Joseph M. Farley Nuclear Plant - Units 1 and 2  
Proposed Technical Specification Change  
to D.C. Distribution System Requirements

## Specific Comments - Battery Technical Specification Change

TABLE 4.8-2

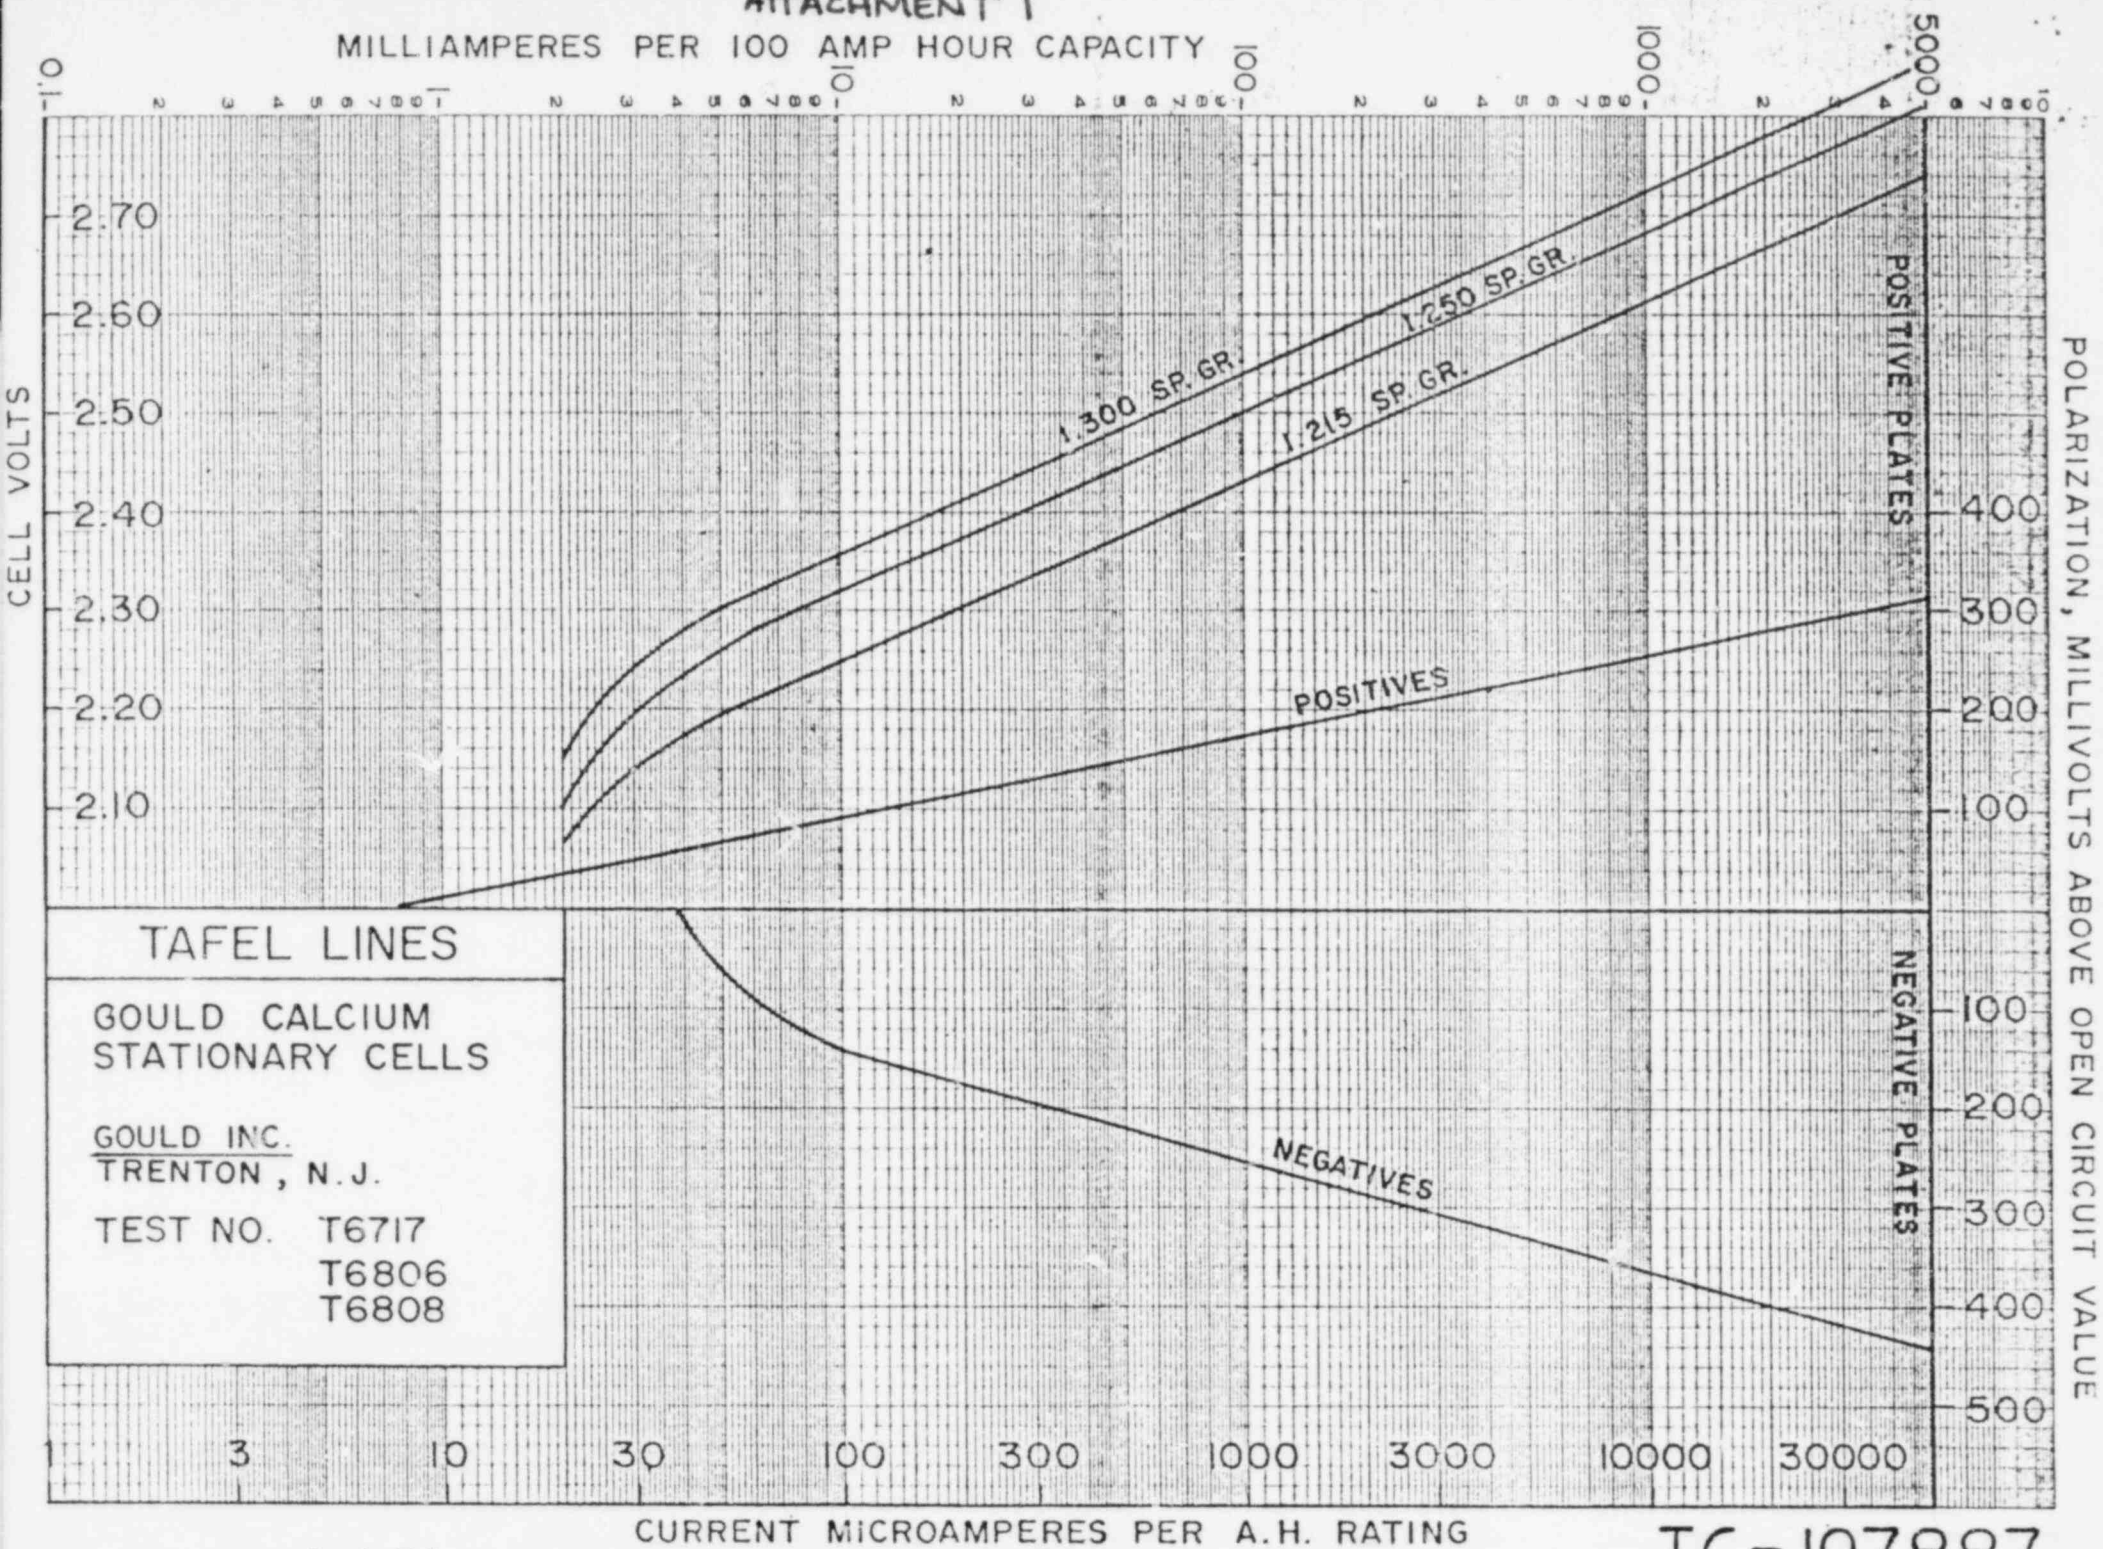
Float Voltage for Category A Limits and Category B Limits should be 2.13 volts vice 2.02 volts and so indicated in T.S. Table 4.8.2.

Float Voltage for Category B Allowable Value should be 2.02 volts.

Specific Gravity for Category A and B Limits should be 1.200 and 1.195, respectively, with the additional requirement that the specific gravity for the average of all connected cells be greater than or equal to 1.205.

Category B specific gravity should have an allowable value of 1.205 for individual cells and an average value for all connected cells of 1.195. The NRC also proposed changing the cell allowable variance from .080 to .020.

The existing Technical Specifications requires a minimum float voltage of 2.02 volts. APCo proposed a float voltage of 2.07 volts in a submittal to the NRC dated May 3, 1983 based upon the guidance of IEEE Standard 450-1980. In accordance with discussions with the NRC Staff, APCo resubmitted, in letter dated January 27, 1984, Table 4.8-2 designating 2.02 volts as the float voltage limit based on the original Technical Specification criteria.

In conclusion, a Category A and B limit of greater than or equal to 2.08 volts with an additional requirement that the average float voltage be greater than or equal to 2.13 volts are considered not only more appropriate float voltage limits, but are enhancements from the existing 2.02 float voltage limit. These limits, considered in conjunction with specific gravity criteria discussed below, are more than adequate to ensure battery operability and capacity.

The NRC proposes that the specific gravity for the average of all connected cells be greater than or equal to 1.205. APCo proposes that the specific gravity be 1.195 which is based on the FSAR required loads plus an adequate margin of 16%. The minimum average specific gravity to meet the FSAR loads is approximately 1.181 as shown in Figure 2 of Attachment 4.

The NRC proposal to change the 0.080 specific gravity value to 0.020 is acceptable to APCo if the wording of the criteria is modified to read:

".020 below the allowable average (1.190) of all connected cells"

(4) The average cell float voltage shall be greater than 2.13 volts in order for the battery to be considered operable. (APCO PROPOSED)

ATTACHMENT 1A

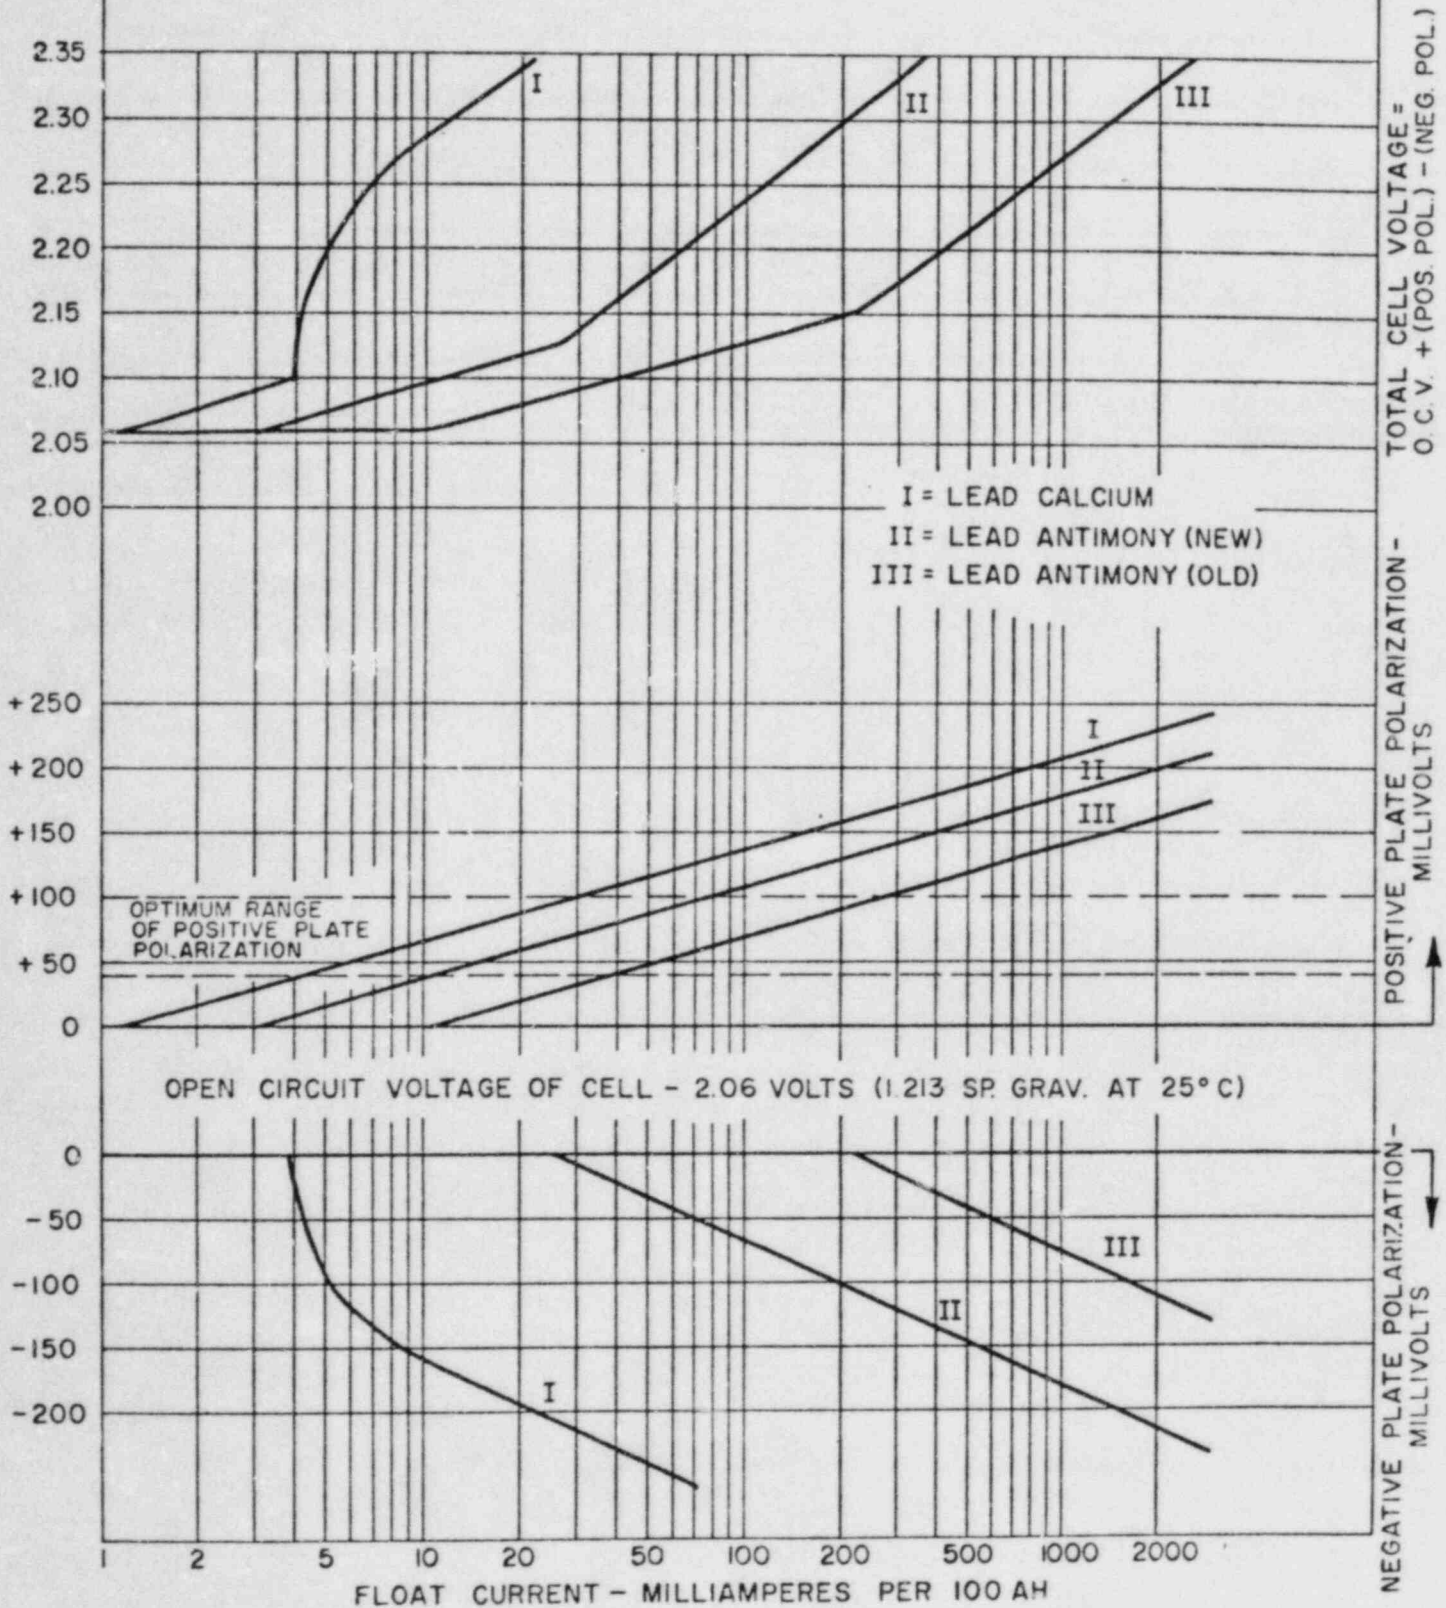
The susceptibility of lead calcium battery cells to variations in float voltage as compared to lead antimony and the reasons for this characteristic are provided in Attachments 1 and 1A which depicts Gould lead calcium cell voltage characteristics and typical lead calcium and lead antimony characteristics. For a Gould lead calcium cell of 1.215 specific gravity, a cell float voltage of 2.2 volts is obtained at a float charge of 5.5 milliamps/100AH. For lead antimony (new battery) this value is typically 63 milliamps/100AH while for an older battery it is over 400 milliamps/100AH. A small change in float charging current of only 3.2 milliamps/100AH on lead calcium cells (e.g., caused by slight battery case leakage due to dust, miscellaneous contamination, or an acidic condition), can cause a cell voltage to drop .1 volts from 2.2 to 2.1 cell voltage. This is below the NRC Proposed value of 2.13 volts and would require, if the NRC value is adopted, APCo to initiate immediate corrective action to equalize voltage. Based on experience at Farley, this is not an indication of a discharge condition, but rather simply a variation in float voltage. Further, the steep slope of the TAFEL Lines of Lead Calcium, shown in Attachment 1 and 1A and comparison of lead calcium and lead antimony float current requirements suggest that lead calcium cells will have a wider float voltage variation per cell than older type batteries (particularly in actual plant environments).

Using Attachment 1, which is applicable to the Farley batteries, negative plate polarization ceases at approximately 2.16 volts and positive plate polarization ceases where no current enters the battery at the open circuit voltage of 2.055 volts. As discussed in Attachment 3, at a positive plate polarization of not greater than 25 millivolts, accelerated positive plate corrosion takes place. Such corrosion seriously degrades battery life if allowed to continue. This value is 2.055 volts, open circuit voltage, plus .025 volts polarization for a total of 2.08 volts. Since this is a value which is critical to overall battery operation, APCo maintains that 2.08 volts is the voltage below which corrective action is required. A value greater than or equal to 2.08 is therefore selected by APCo for limits in Category A and B. It should be further noted, however, that even though a cell may be in jeopardy for the long term at 2.08 volts, the capacity of the battery is still not known until specific gravity is measured. Cell voltage and specific gravity in combination are, in APCo's opinion, accurate indicators of battery condition whereas cell voltage alone is not.

FIGURE 1  
TYPICAL DISCHARGE CHARACTERISTICS OF NCX-1800

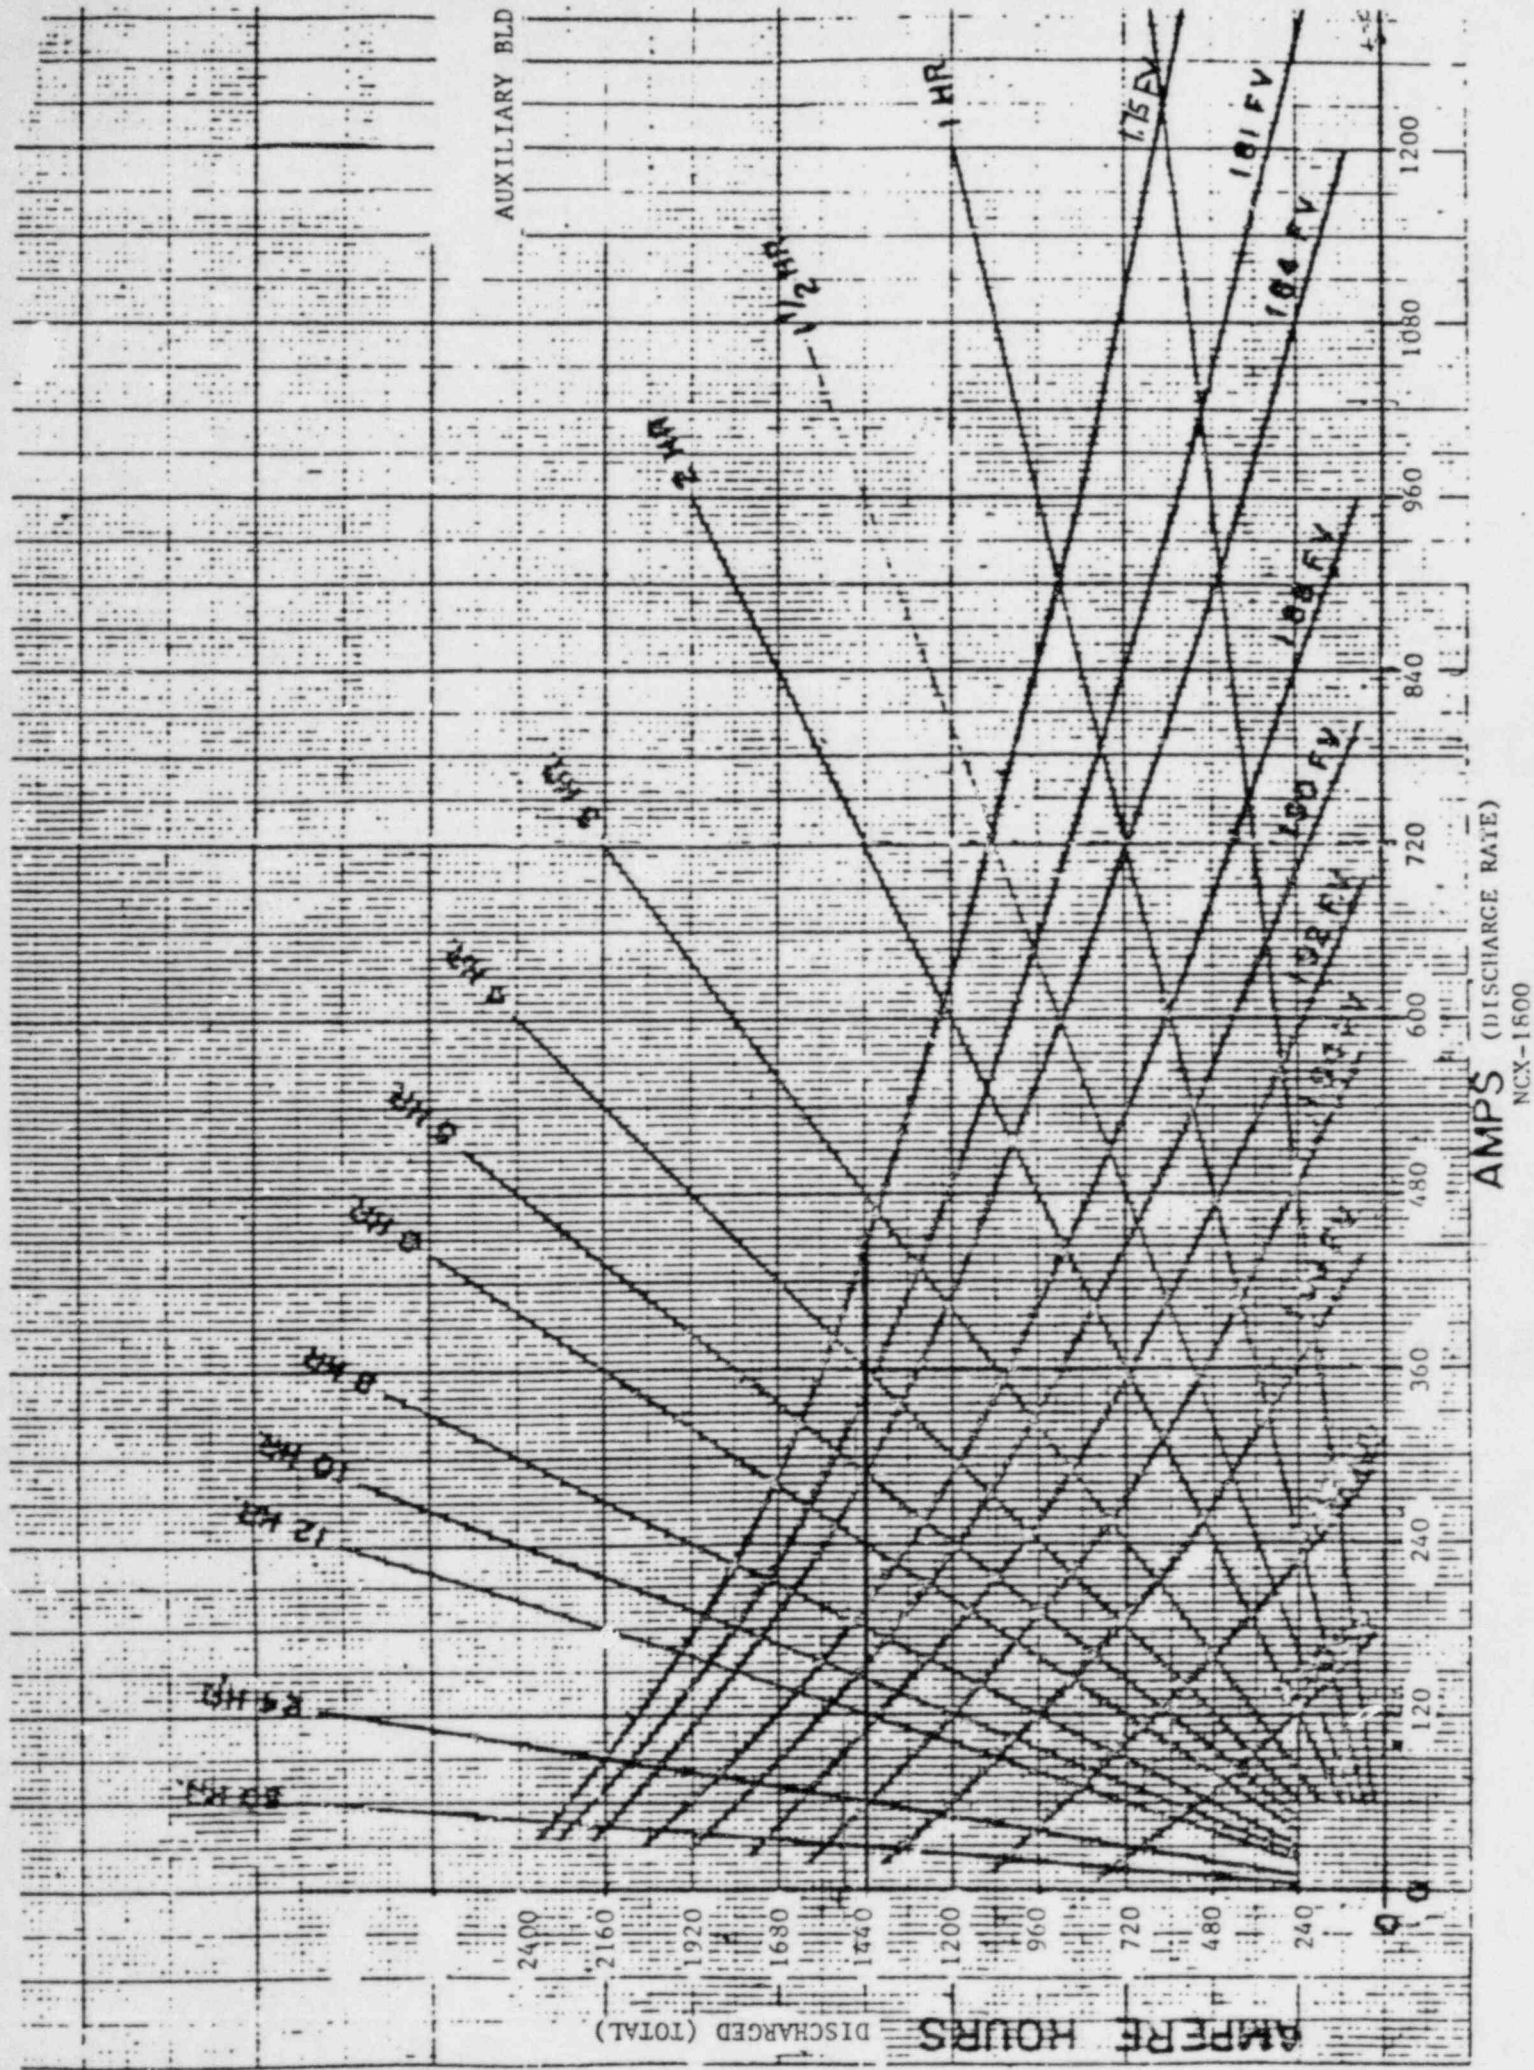
2. Using the manufacturer's discharge curve for the NCX-1800 (See attached Figure 1, Typical Discharge Characteristics of NCX-1800) and the average discharge rate of 442 amps, the total amp hours available is 1440. The availability of 1440 amp-hrs in the battery is obtained by selecting 442 on the "X" axis, extending vertically until the 1.75 volt (FSAR 8.3.2.1.1) line is intersected, and then extending left horizontally to the "Y" axis where Amp-Hrs. (AH) is read as 1440. Note that the 442 amps is an average discharge rate. We consider this to be a conservative (on the high side) rate since battery characteristics are such that the lowest discharge rate, 430 amps in this case, should be used which would provide for a capacity total of over 1440 AH by using the same process as before, only starting at 430 amps on the "X" axis.
